City of Ryde Submission

North Ryde Station Precinct – Modification 6 SSD-5093-Mod-6

Modification of North Ryde Station Precinct SSD-5093 - Increase GFA, modify building layout, open space, roads.

Submission Date: 26 September 2023

Figure 2: Markup of Garungul (unbreakable) Wicks Road South Precinct Structure Plan (Base Source: Macquarie Park Strategic Masterplan – page 135)

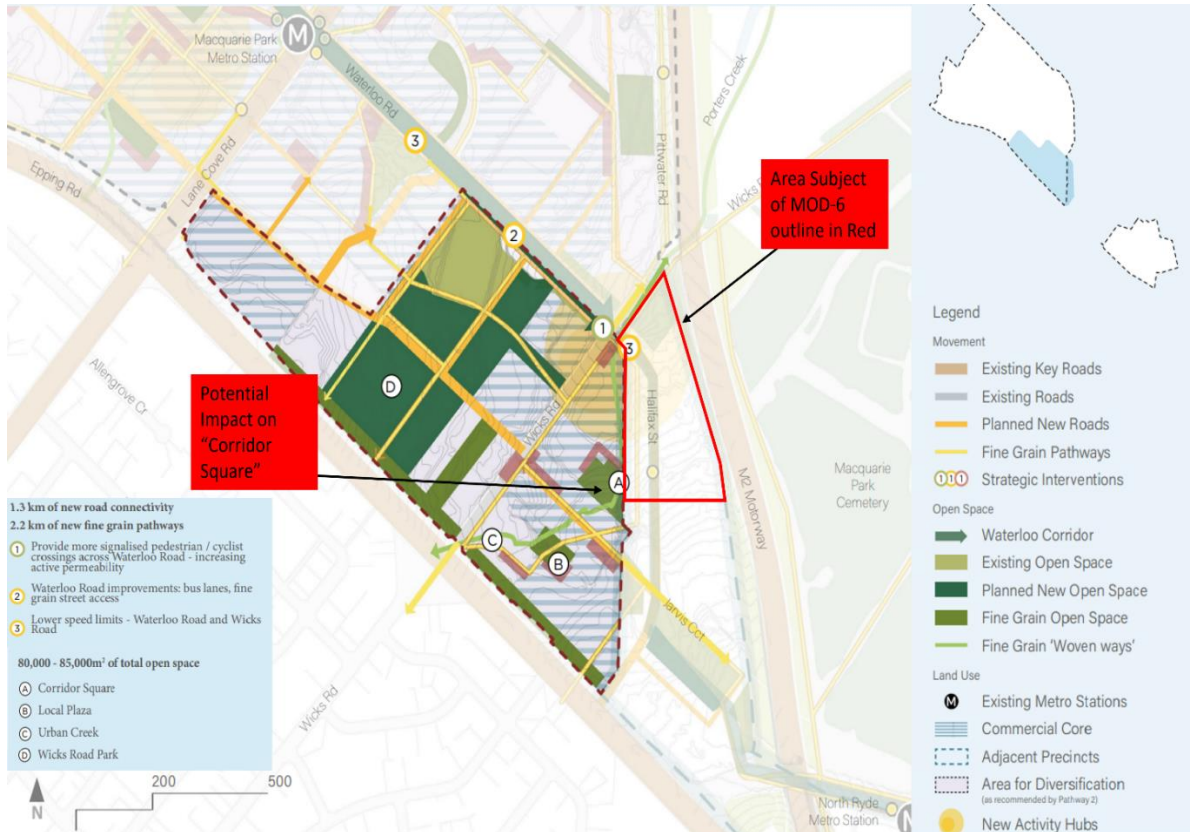
- Proposal will need to consider solar access implications to the linear park along Halifax Street and the proposed open space within the Wicks Rd South/Garungul precinct in the MPPS. Whilst possibly a mistake, it appears in review of FJC Studio's Urban Design Report (Solar Studies), shadow studies from between 9am to 12am on the 21st of June are omitted from the package. Notwithstanding, the land west of the subject site is noted to be public open space under the MPPS, specifically being identified as the "Corridor Square" (Figure 2).

- As shown in Figure 2, land adjacent is marked as being developed into a green corridor square used for public open space purposes, whilst MOD-6 is proposing a GFA uplift to the buildings on the western side of the precinct to enable built forms of up-to 13 stories, which is double what was envisaged under SSD-5093 (Figure 3). This mass and height uplift not envisaged under SSD-5093 causes concern from an overshadowing and visual impact point of view.

- The schemes information lacks clarity on the consideration of the future character of the Macquarie Park Precinct (Garungul) that it will be interfacing (Figure 2), and the associated impacts on this space. Whilst it's noted to be of an industrial character (existing), the character of the area will change, consistent with the structure plan. Given this, further information is required on the following:

- Detailed Solar Studies (from 9am Winter Solstice) showing the expected impact on Corridor Square. The Applicant is to note the design criteria of this Precinct, particularly noting that in respect of overshadowing the design criteria requires:

- Open spaces are to have solar protection between 10am-2pm on the winter solstice.

Figure 4: Mark up of Land Application Map (Base Source: LLUDGL – City of Ryde Council)

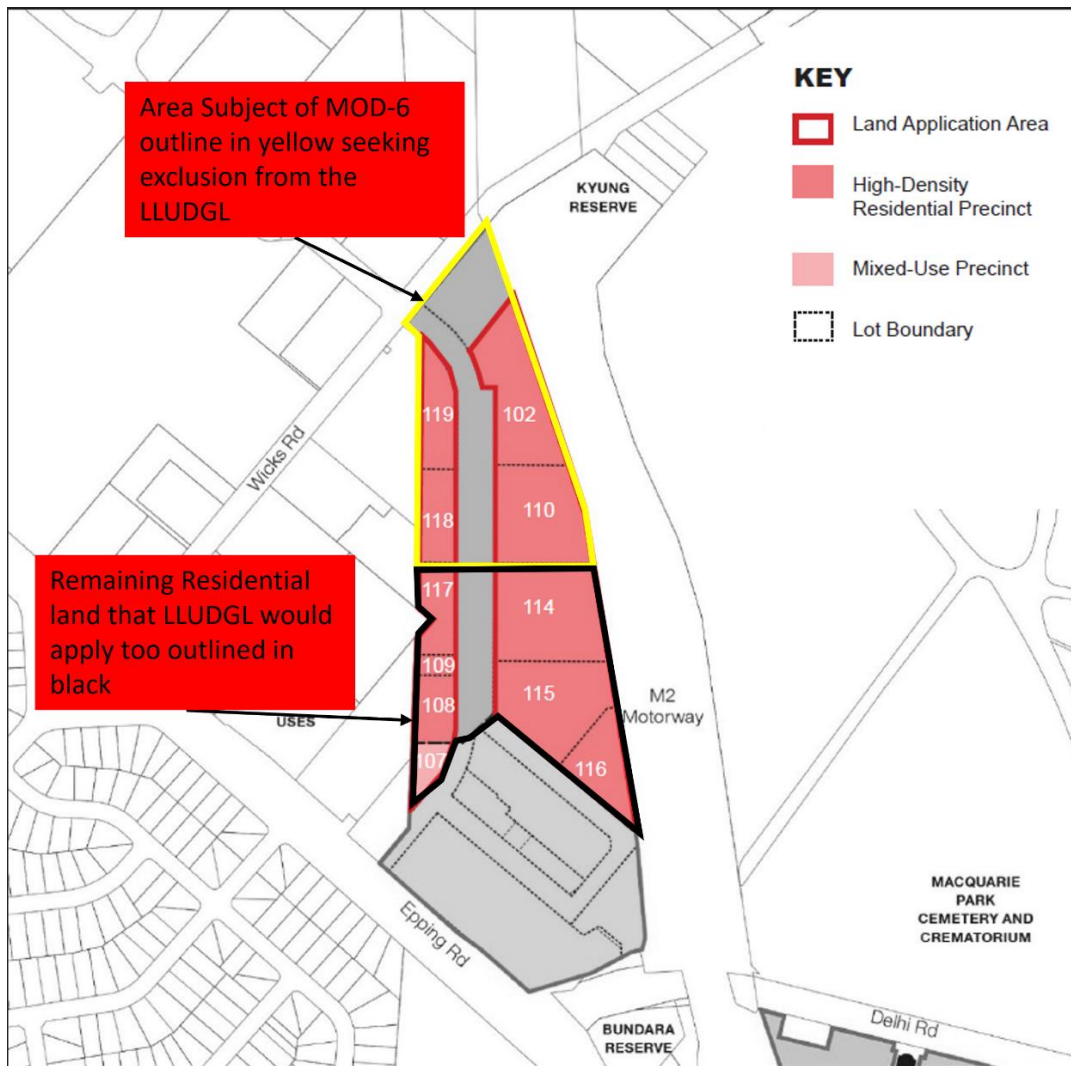
Notwithstanding the above, the Applicant's approach of only applying their guidelines to half of the entire residential precinct (Figure 4), is inappropriate and does not deliver a cohesive vision for the precinct and could result in a vastly different urban design outcome as two different urban design guidelines would apply to either end of the precinct (if approved). The Applicant's approach is not supported by Council, particularly as Council has a prepared detailed design guideline that applies to the **entire** Residential Precinct under SSD-5093 known as the "*Urban Design Guidelines for High-Density Residential Precinct & Lot 107 Lachlan's Line*" (LLUDGL). These Guidelines will be attached under separate cover (**Attachment 2**).

The SEARs request outlined that the Proponent was to propose amendments to the *North Ryde Station Precinct Development Control Plan 2013* (NRSP -DCP), however this DCP is an outdated planning instrument that does not relate to SSD-5093. The NRSP-DCP came into force on 4 December 2013, Whilst SSD-5093 was approved by the Minister of Planning on the 5 of March 2015.

In response to SSD-5093 Council prepared a detailed site specific guideline (dated 12 July 2019) as outlined above that applies to SSD-5093 and contains fine grain planning outcomes related to development applications. The LLUDGL supersedes NRSP-DCP and contains controls that were within the NRSP-DCP however more relevant to SSD-5093. Whilst the LLUDGL has not formally been adopted by Council, it is accepted that it's the applicable planning instrument that a detailed DA for high-rise residential development within Lachlan's Line would be assessed against, which Council has recently applied to LDA2022/0390 (5 Halifax Street).

The Applicants Planning Report and Urban Design package has undertaken a detailed assessment of an outdated planning instrument that wouldn't ordinarily be applied to at a detailed DA and then further seeks to implement their own design guidelines to a portion of the precinct. The Applicant has undertaken no assessment of the scheme's consistency with the LLUDGL, or how it deviates, although are aware that its applicable.

Rather than seek to exclude applicability of the LLUDGL from the Applicant's land, Council would request that the Applicant, in-conjunction with Council, propose amendments to the LLUDGL, with final approval from Council and then have them formally apply to SSD-5093, via an amendment to condition E2.

~~NORTH RYDE STATION PRECINCT DCP~~ *Lachlan's Line Urban Design Guidelines*
E2 Future Development Applications shall demonstrate that the development has been designed in accordance with the requirements of North Ryde Station Precinct Development Control Plan (NRSP DCP) and the City of Ryde Urban Design Guidelines for High-Density Residential Precinct & Lot 107 Lachlan's Line (LLUDGL) and achieves the vision for North Ryde Station Precinct as set out in the NRSP DCP LLUDGL.

Figure 5: Markup of FJC Studio's Urban Design Report (Base Source: FJC Studio)

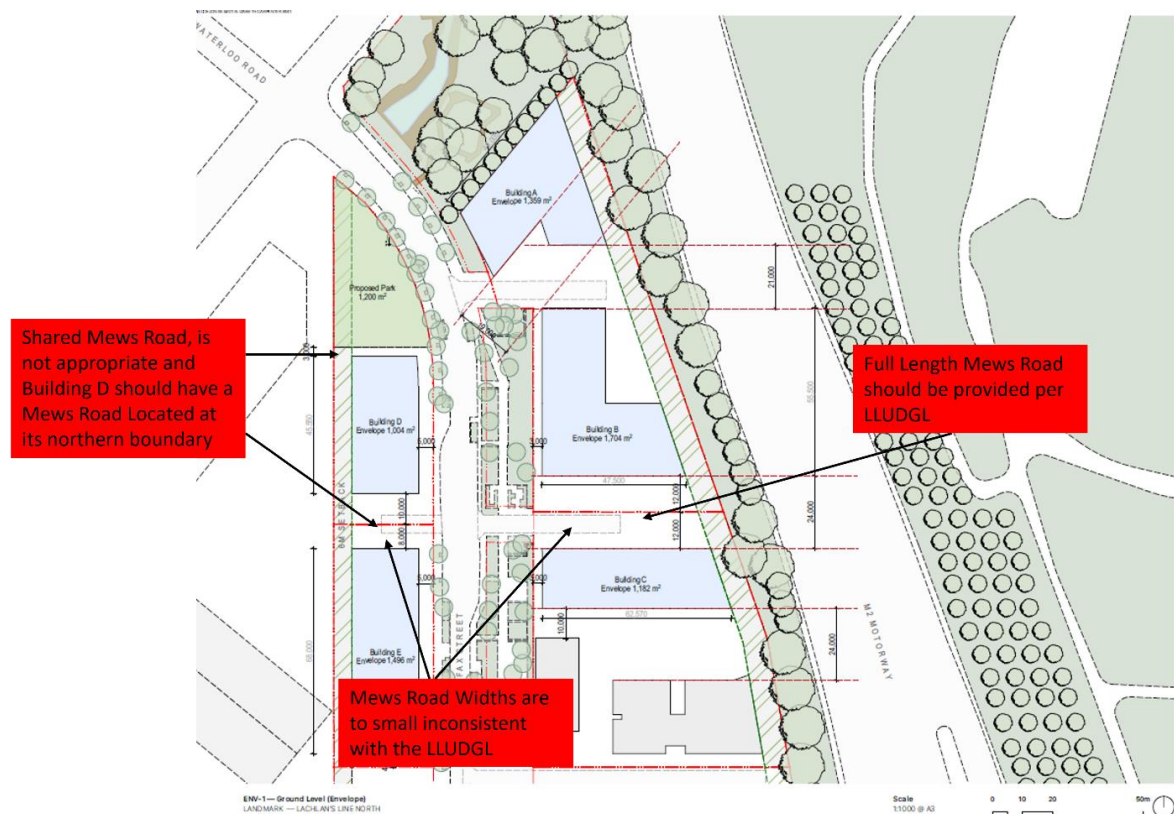
- The Applicants Gross Building Area is inconsistent with the LLUDGL which requires 1090m² for over 8 storeys. The applicant proposes the following:
 - Building C – 1179m²
 - Building E – 1521m²
- The proposed urban design guideline amendment does not contain the Mews Roads in the required widths, locations or setbacks that is envisaged under the LLUDGL as shown by Figure 5. Full length and width Mews Roads should be provided in appropriate locations to support the additional GFA increase, particularly as it would result in more density within the Precinct. The Mews Roads purpose is to enable access (waste and residential) and provide space for car share arrangement in the precinct that would support reduced parking rates.

- Please refer to Attachment 2 for the design requirements of the Mews Roads.
- Building Staging. The Applicants Staging plan (Figure 13 of FJC Studio Urban Design Report) shows that 5 Halifax Street will be built in 2 stages, with the southern built form on the site being delivered under stage 1 whilst the northern aspect of the site being delivered under stage 4. Stage 4 contains the access point into stage 1, so it is unclear the strategy of delivering the access point into the site at a later stage. Without appropriate access to the site, it will be unable to be occupied. This should be revised.

Figure 6: Markup of FJC Studio's Separation Plan (Base Source: FJC Studio)

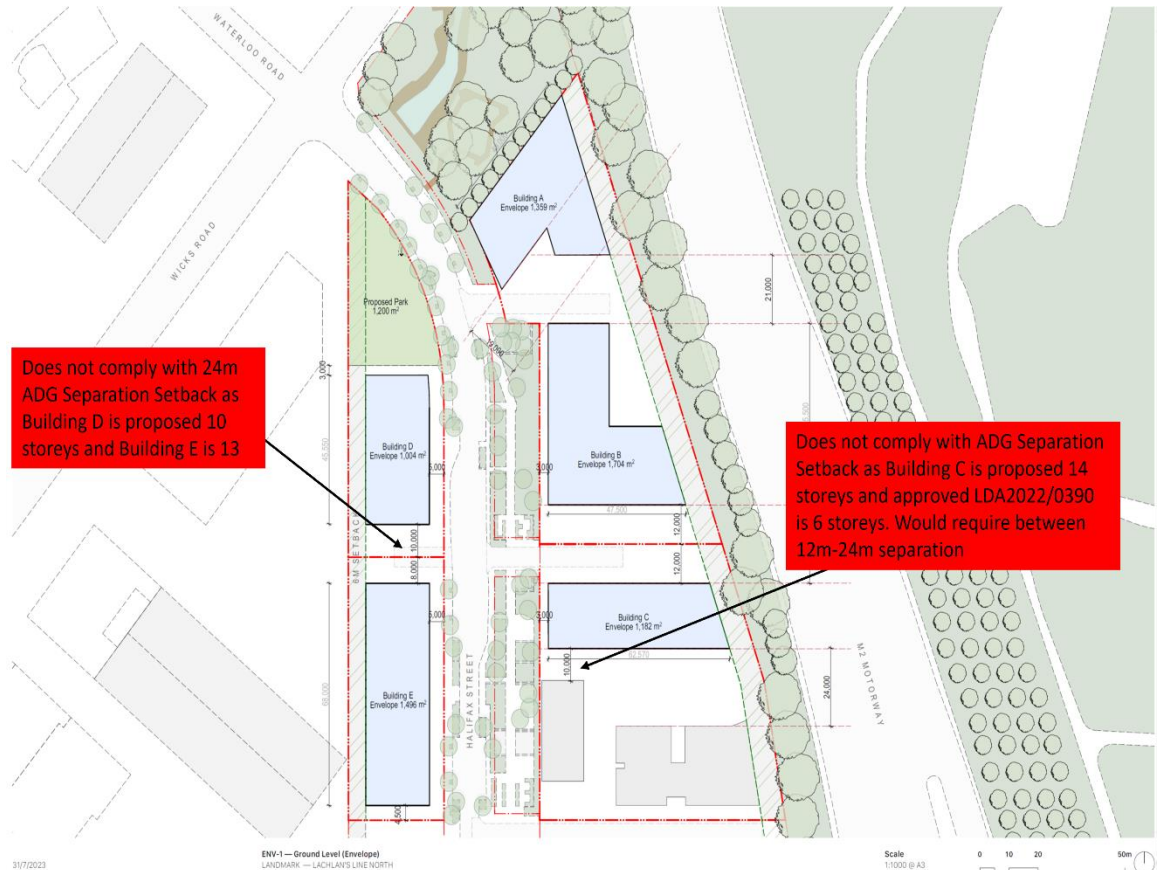
- In review of the setbacks proposed in the FJC Studio's Urban Design Report the proposed buildings that are non-compliant with the ADG building separation distances (Figure 6 & Figure 7). The Applicant addresses this through alternative means such as building orientation to prevent direct sightlines and screening. This is however a poor planning and design outcome as it will result in compromised amenity

for future residents. Of key concern are the proposed setbacks of Lot 110, Lot 118 and Lot 119. Further clarification on building separations and building siting is required and compliance with ADG is required. Council contends that this matter should not be left to a detailed DA matter and should be resolved at a concept level. Further consideration should be given to a taller slender building for Building E, as situated on a lot with a 75m height control under the RLEP 2014. Any consideration to a taller and slender building should be complemented with amended solar studies examining the impact of shadows cast onto the Linear Park, and the Garungul Precinct.
